CPED STAFF REPORT
 Prepared for the Board of Adjustment

BOA Agenda Item #6
 December 11, 2014
 BZZ-6924

Property Location: 1100 & 1118 University Avenue Northeast
Prepared By: [Andrew Liska](#), City Planner, 612.673.2264
Applicant: McDonald’s USA, LLC
Project Contact: Ray Croaston Jr.
Required Applications:

**APPLICATION FOR
ZONING ADMINISTRATOR APPEAL**

SHEET NO. C2.5
 FILE NAME: C205MCD247.DWG
 PROJECT NO. MCD13241

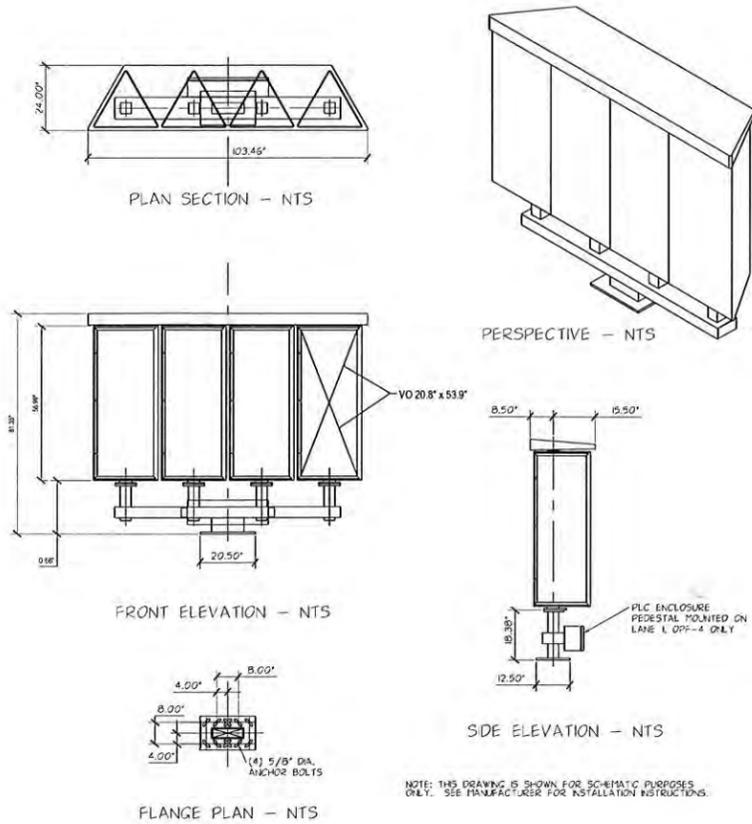
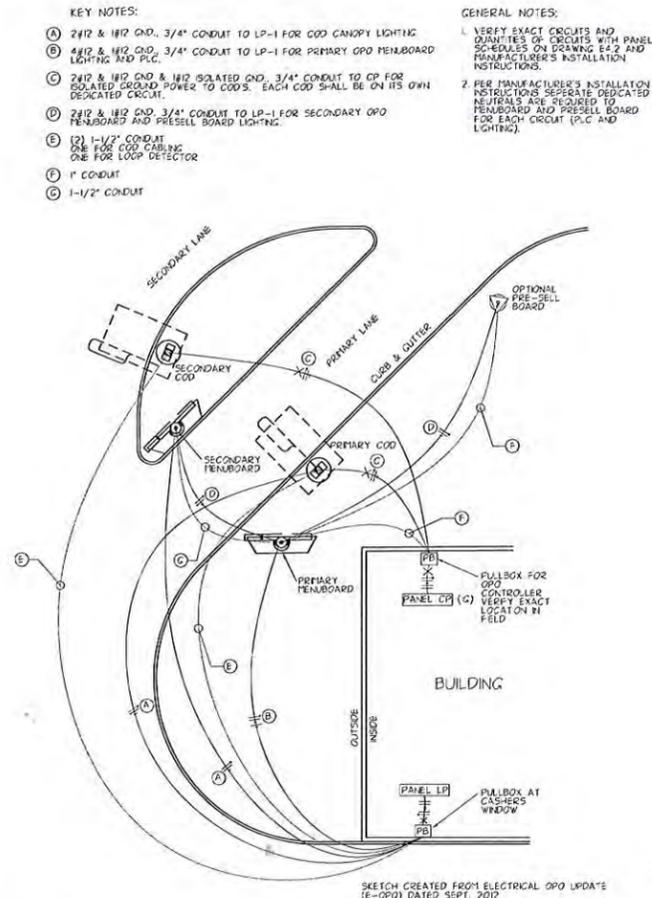
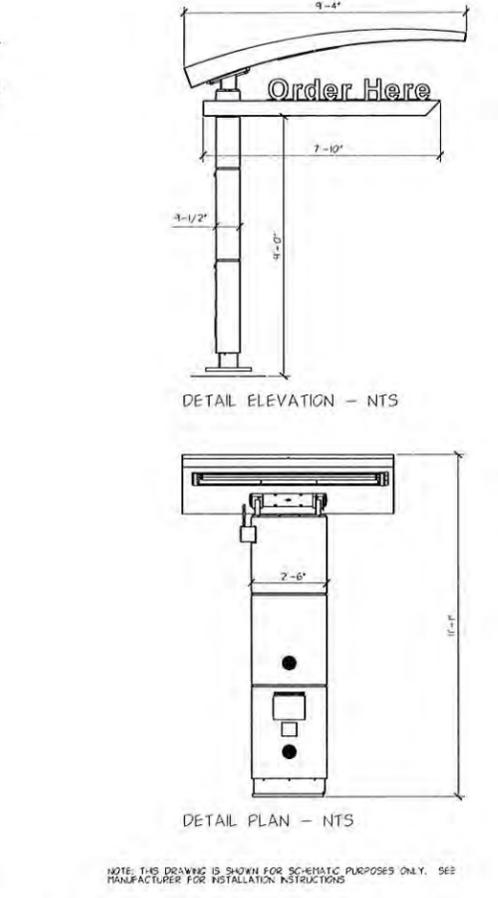
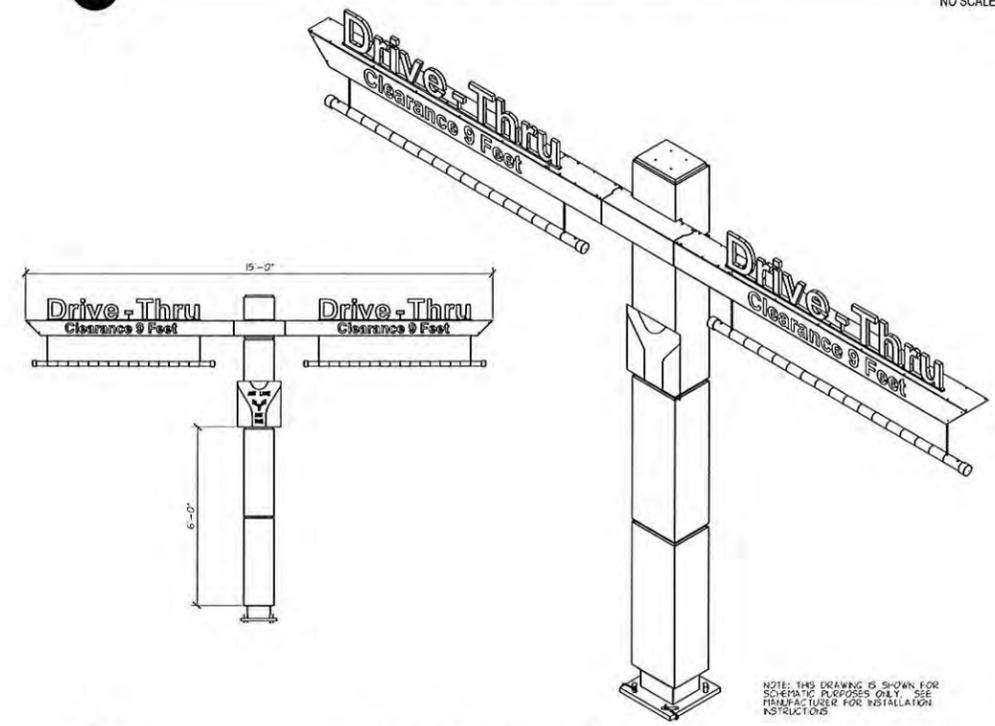
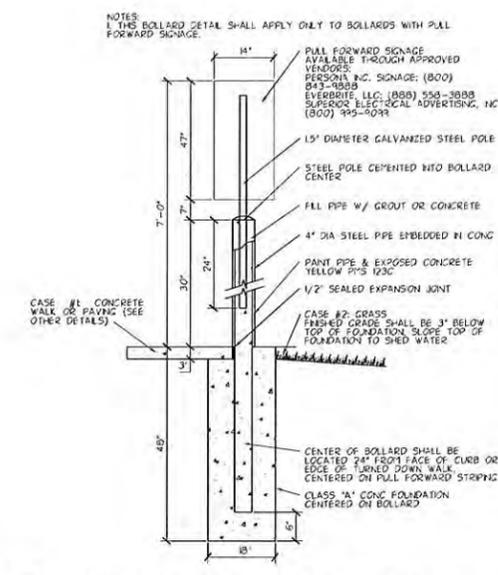
SUMMARY OF ACTIONS. Variance C to increase the height of the menu boards was denied thus, the maximum height is 6' per Chapter 543.370. Variance D to increase height of freestanding signs was approved thus allowing the "Order Here" signs to increase from 8' to 10' 3" and the "Drive Thru" sign to increase from 8' to 10'9".

SIGN	PERMITTED	MEASURED
MENU BOARD I	72"	84.5"
MENU BOARD II	72"	85"
"ORDER HERE" (COD) I	10' 3"	10'8"

“ORDER HERE” (COD) II	10’3”	10’8”
DRIVE THRU (GATEWAY)	10’9”	11’7”

GRADE DETERMINITION. While some of the signage is slightly different in size than as approved; the nature of this appeal is regarding where the signage is being measured from. Chapter 520.160 defines *Grade, Natural* as, “*The grade of a site before it is modified by moving earth, adding or removing fill, or installing a berm, retaining wall or other earthwork feature. Natural grade is determined by reference to a survey, or other information as determined by the Zoning Administrator.*” The Zoning Administrator determined natural grade on this site to be the elevation of the drive aisle and parking lot before the most recent construction and addition of new drive thru aisles, curbing, and concrete footings.

Chapter 546.80 Computation of Sign Height states, “*Sign height shall be calculated as the vertical distance from natural grade measured at a point either at curb level or ten (10) feet away from the middle of the sign.*” The Zoning Administrator determined the referenced curb level is that of the curb at the public right-of-way and not interior curbing associated with the drive thru aisles. Using Chapter 546.80 to determine grade, a point ten (10) feet in from the exterior curb of the site is considered natural grade. Natural grade is the elevation of the former driveway and parking lot. Much of this remain unchanged and thus it was determined to measure the signs from the drive thru aisles and not the new curbing and concrete footings recently installed. All of the sign heights are measured from the drive aisles as this is the elevation that the Zoning Administrator determined to be natural grade and all are found to be in violation of the permitted sign heights.

Using natural grade in regulating sign height is critical. Relying on grade alone to measure sign height incentivizes the adding of fill and increasing grade to achieve higher signage. Natural grade is the necessary check that counters artificially adding fill to increase elevation and thus, signage that does not match the character of the area.

The appellant argues that the sign heights should be measured from Chapter 520.160’s definition of *Grade*, “*the lowest point of elevation of the surface of the ground, paving, or sidewalk within the area between the building and the property line or, when the property line is more than five feet from the building, between the building and a line five (5) feet from the building.*” Based on the measurement assuming grade at the point five (5) feet from the building, the signage may be close to the permitted height.

Nonetheless, staff finds that the Zoning Administrator has correctly determined height and that the signs exceed the maximum allowed height.

The Department of Community Planning and Economic Development recommends that the Board of Adjustment **deny** of the application to appeal the decision of the Zoning Administrator regarding the height of the two menu board signs at 1100 & 1118 University Avenue Northeast.

The Department of Community Planning and Economic Development recommends that the Board of Adjustment **deny** of the application to appeal the decision of the Zoning Administrator regarding the height of the “Order Here” sign at 1100 & 1118 University Avenue Northeast.

The Department of Community Planning and Economic Development recommends that the Board of Adjustment **deny** of the application to appeal the decision of the Zoning Administrator regarding the height of the “Drive Thru” gateway sign at 1100 & 1118 University Avenue Northeast.
